RE: Prairie Point Site Plan No 1 (Kings Point North) Fourth Submission Review Response to Comments

On behalf of Clayton Properties Group LLC, EMK Consultants Inc., Fox Tuttle Transportation Group, and Terracina Design, we have reviewed the comments from the 4th Submission Review for the Prairie Point Site Plan No1 (Kings Point North) and Plat. The following is a response to comments:

STREET GEOMETRY LIMITS (1"=200')

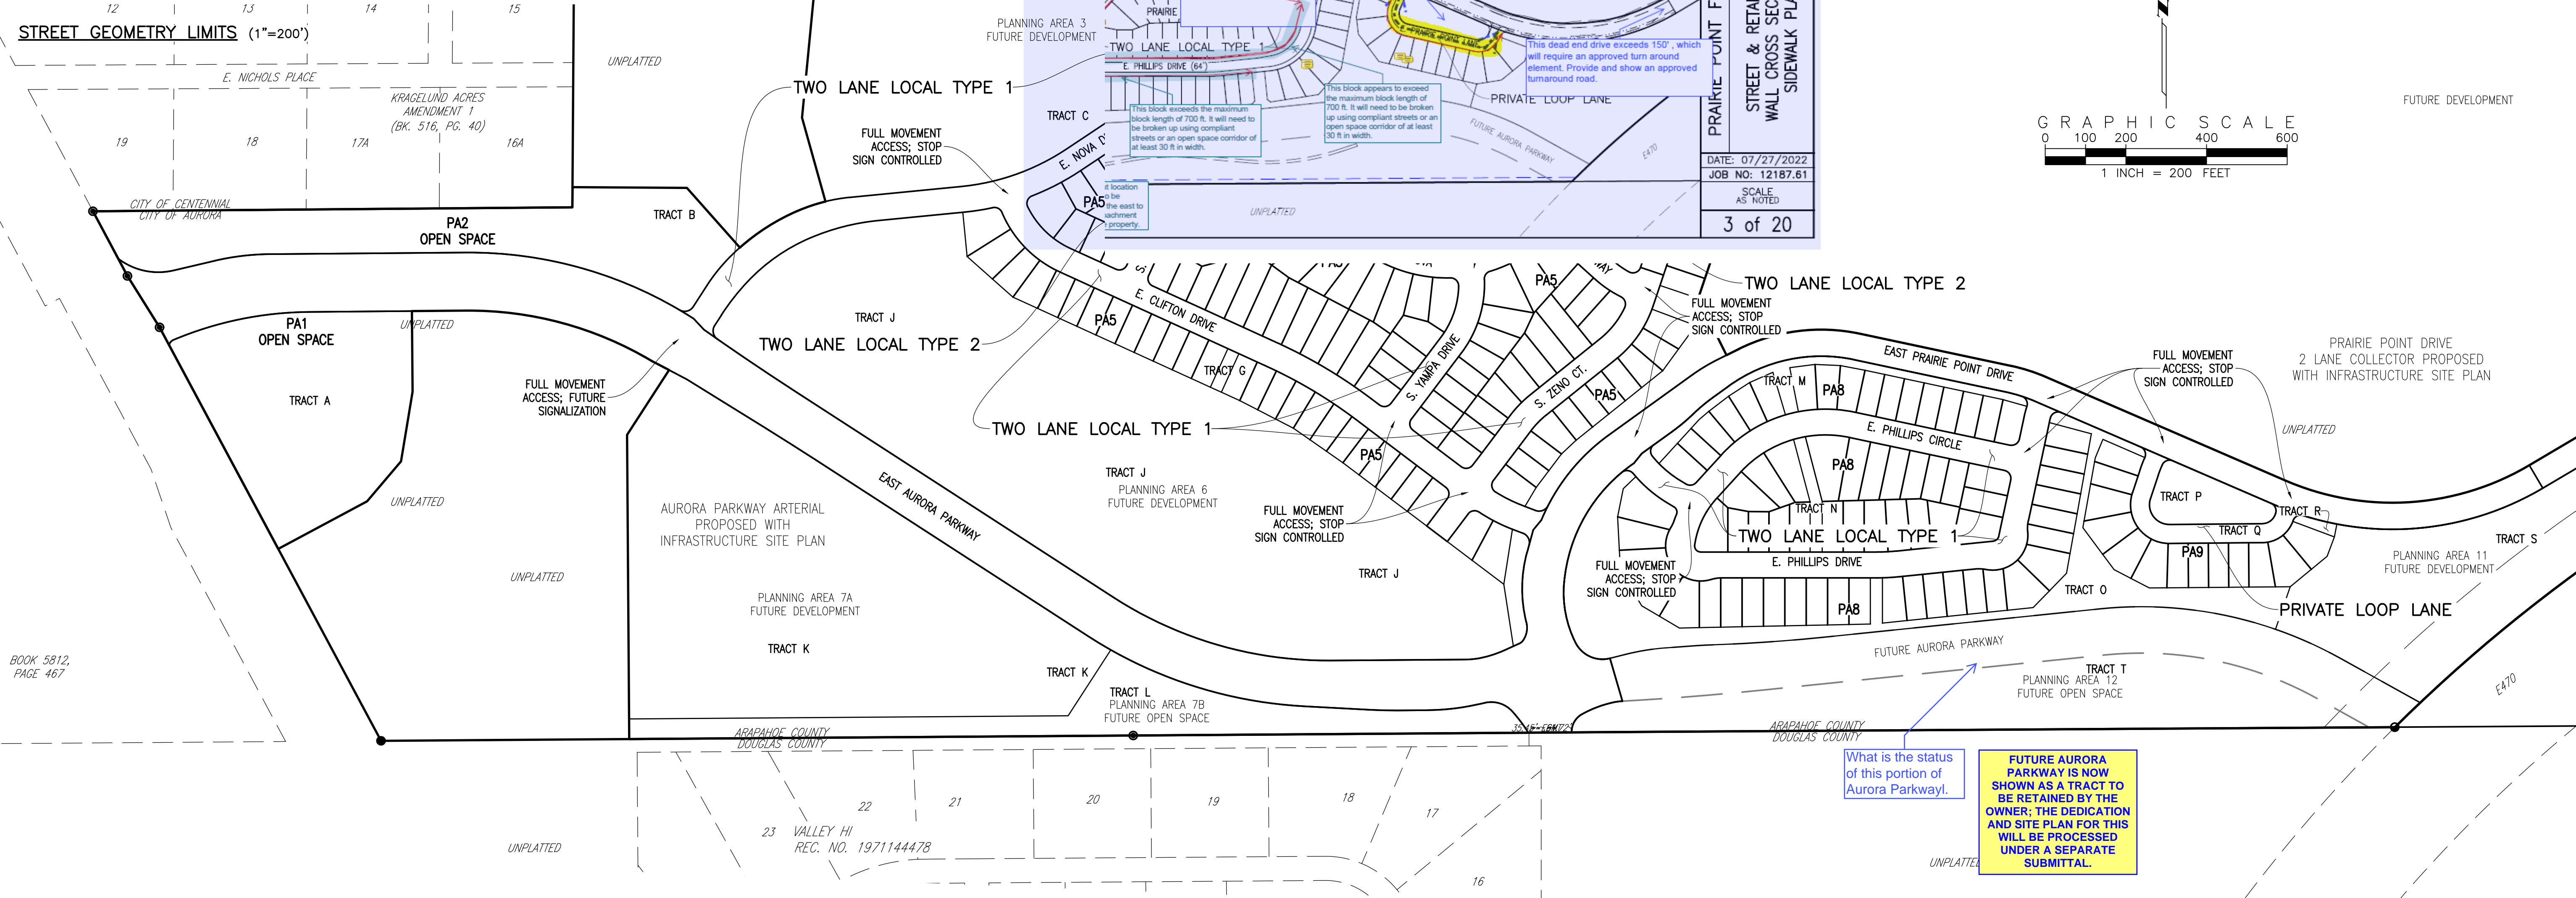
It appears the looped lane hasn't been updated to reflect the 23' fire lane easement. Please update the site and plat to show the fire lane easement.

THE TYPICAL SECTION FOR THE LOOP LANE HAS BEEN UPDATED AND THE FIRE LANE EASEMENT HAS BEEN ADDED TO THE PLAT.

PRAIRIE POINT FILING 1
STREET LIGHTING, TRAFFIC SIGN, & RETAINING WALL DETAILS

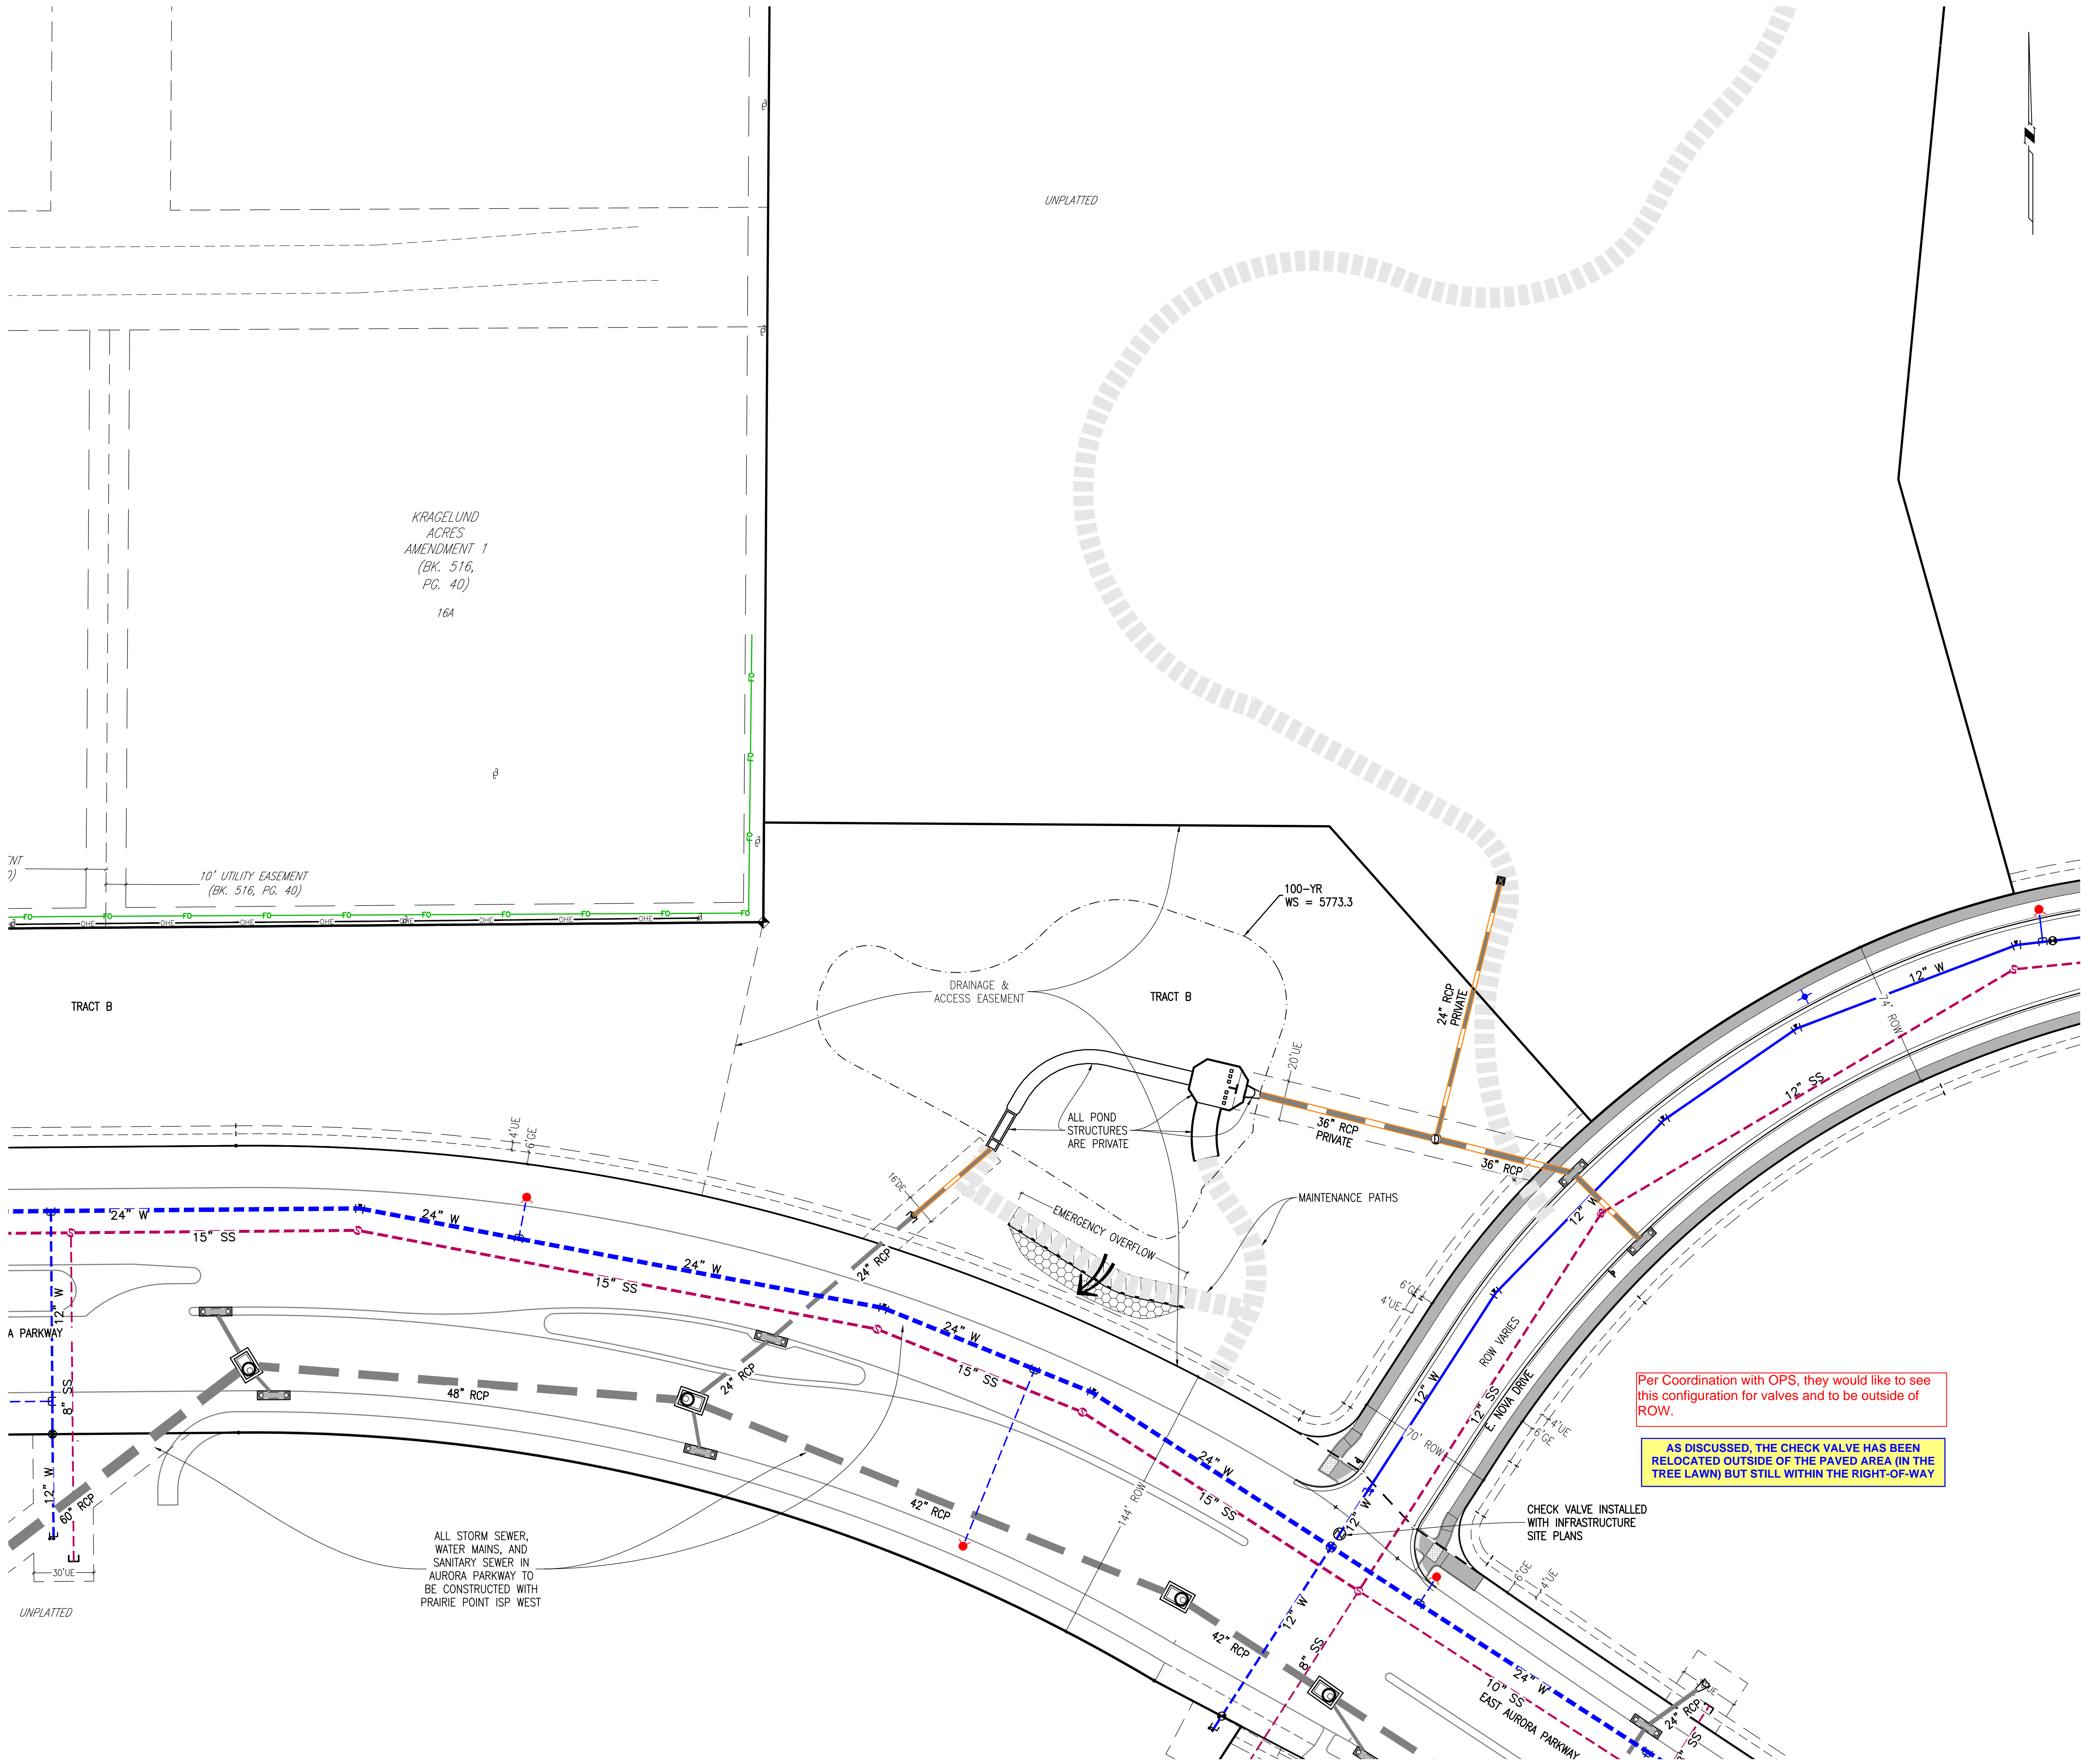
- [Site Plan Page 13]
- b. Repeat: Remove references to Xcel for street lighting on public streets. The new Roadway Manual has been adopted and includes COA standards for poles and fixtures. The fixtures and pole shall match COA standards:
https://cdnsm5hosted.civiclive.com/UserFiles/Servers/Server_1881137/File/Business%20Services/Development%20Center/Code%20&%20Rules/Design%20Standard/Engineering%20Design%20Standard/LightingEquipment.pdf

THIS SHEET HAS BEEN REMOVED. THE RETAINING WALL DETAIL HAS BEEN MOVED TO SHEET 3.

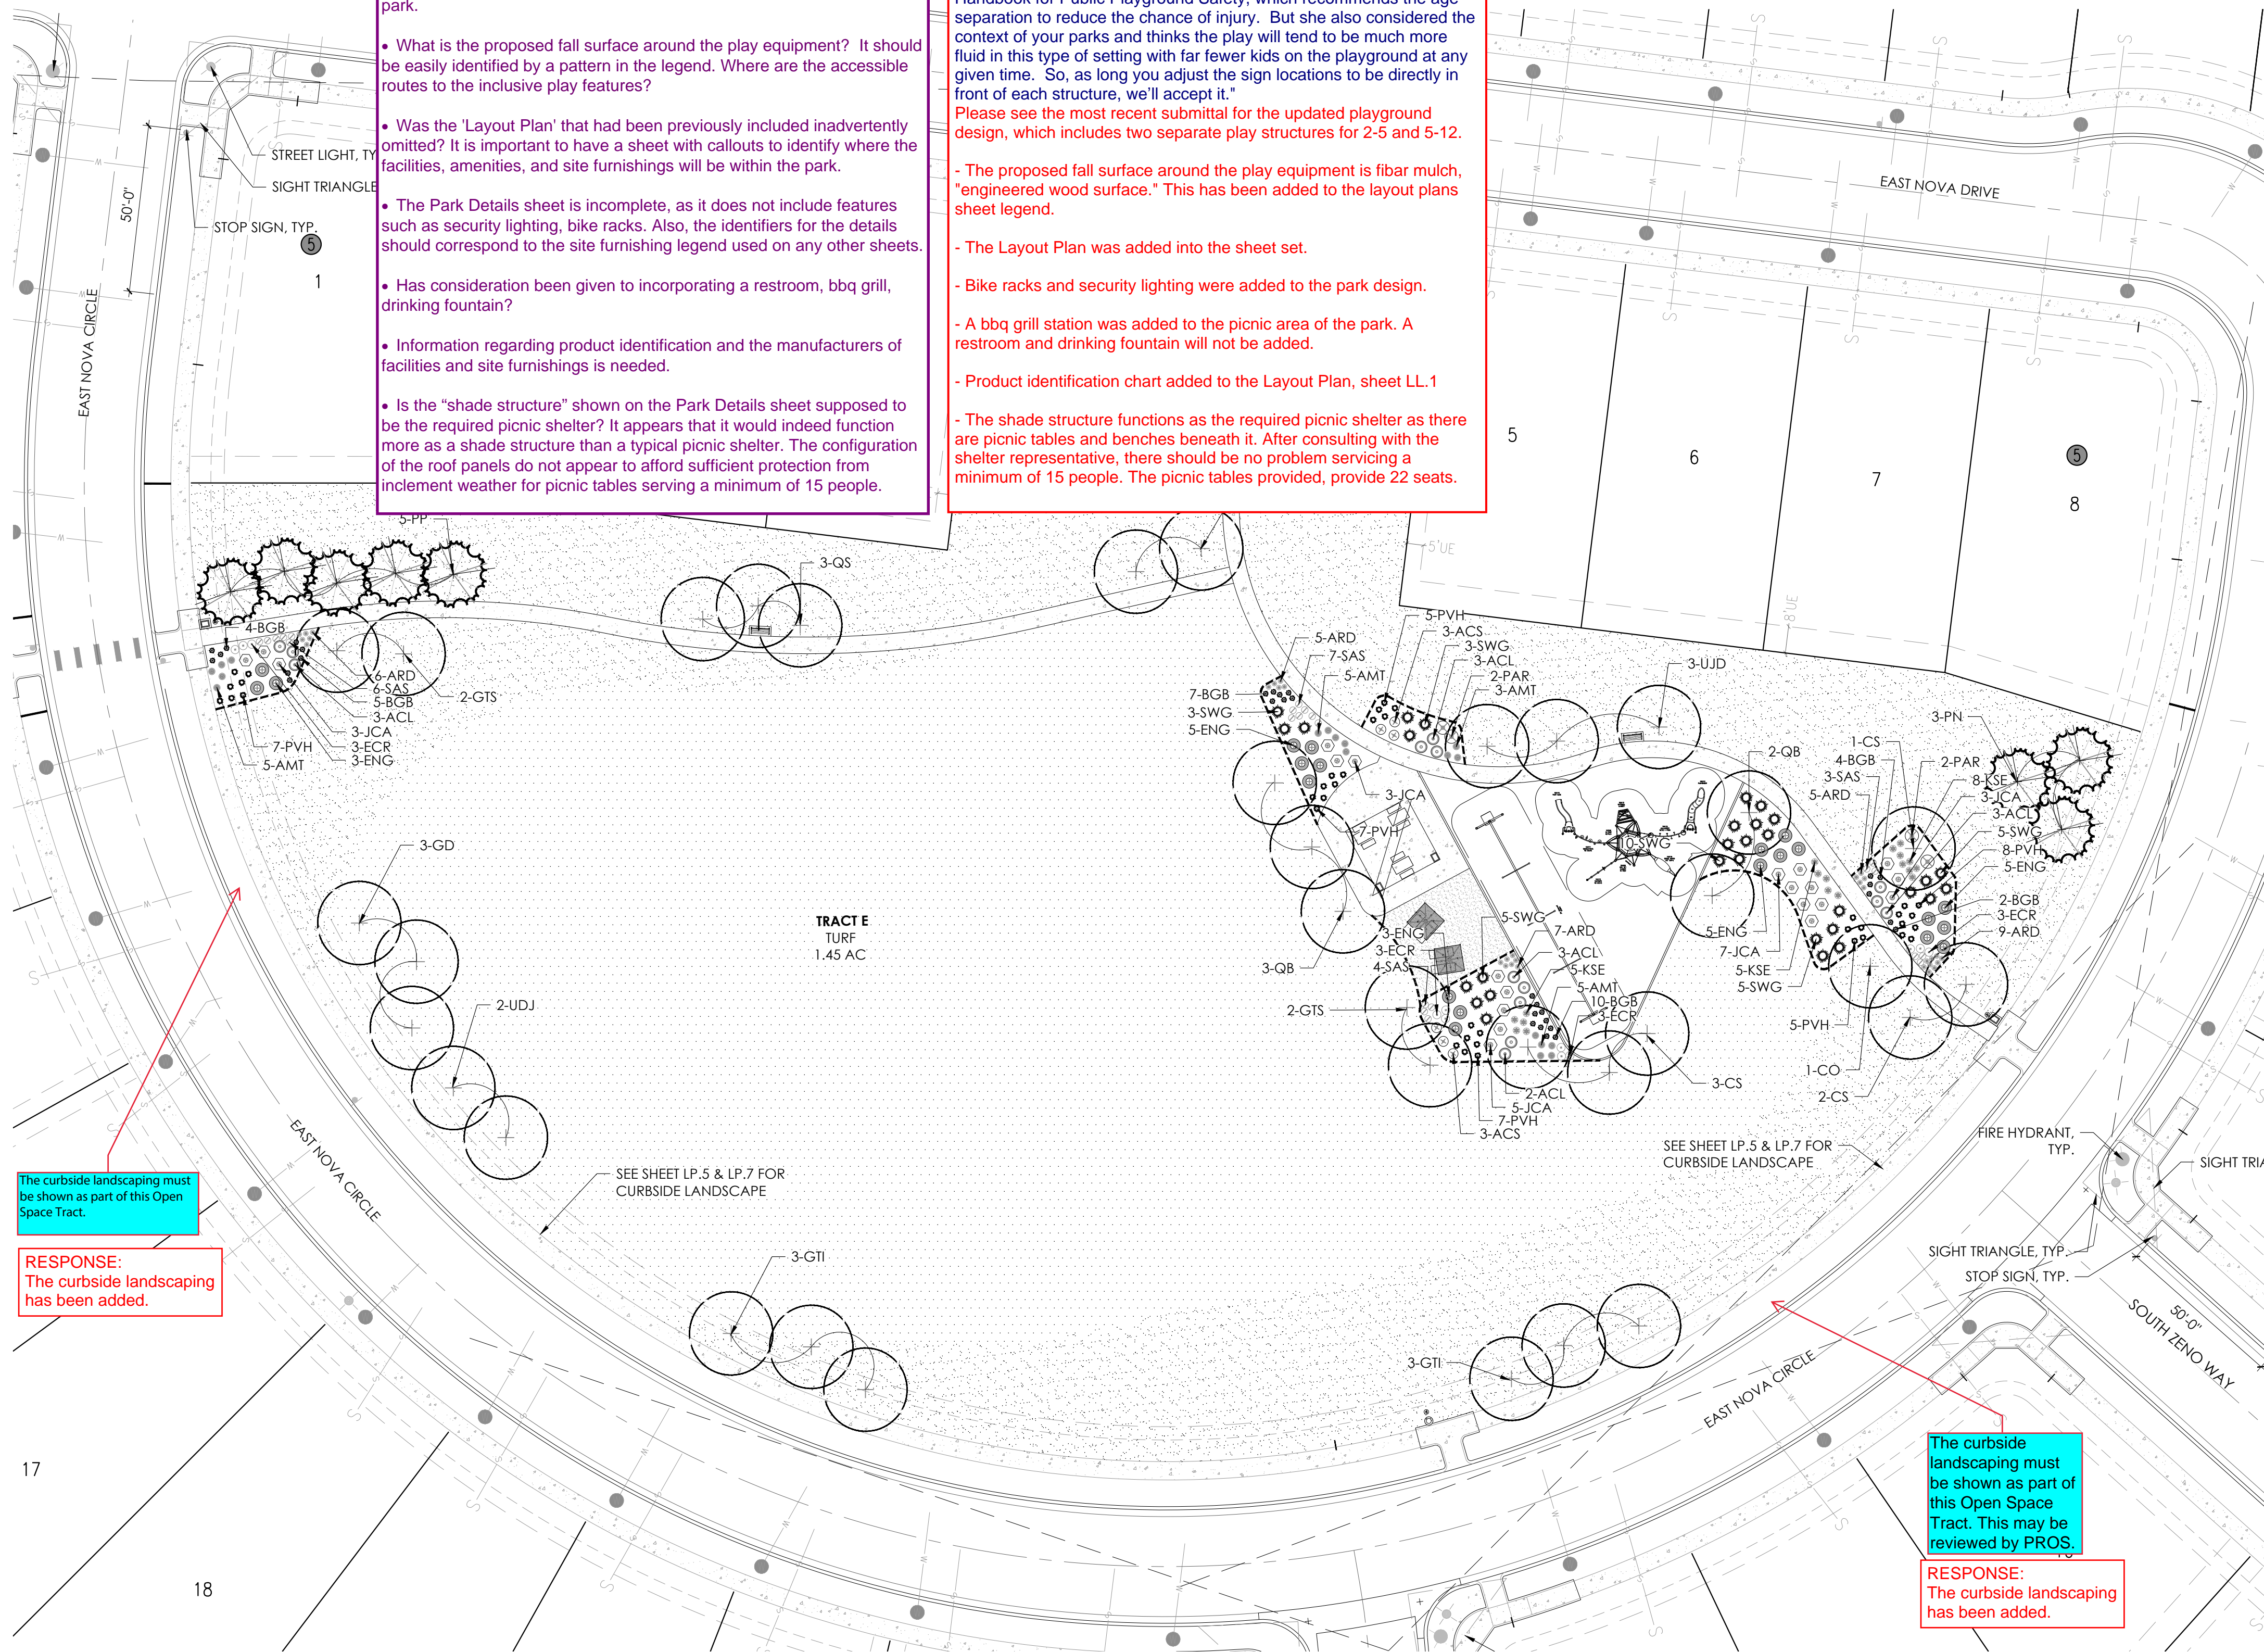
The curbside landscaping must be shown as part of this Open Space Tract.

The curbside landscaping must be shown as part of this Open Space Tract. This may be reviewed by PROS.

RESPONSE:
The curbside landscaping has been added.
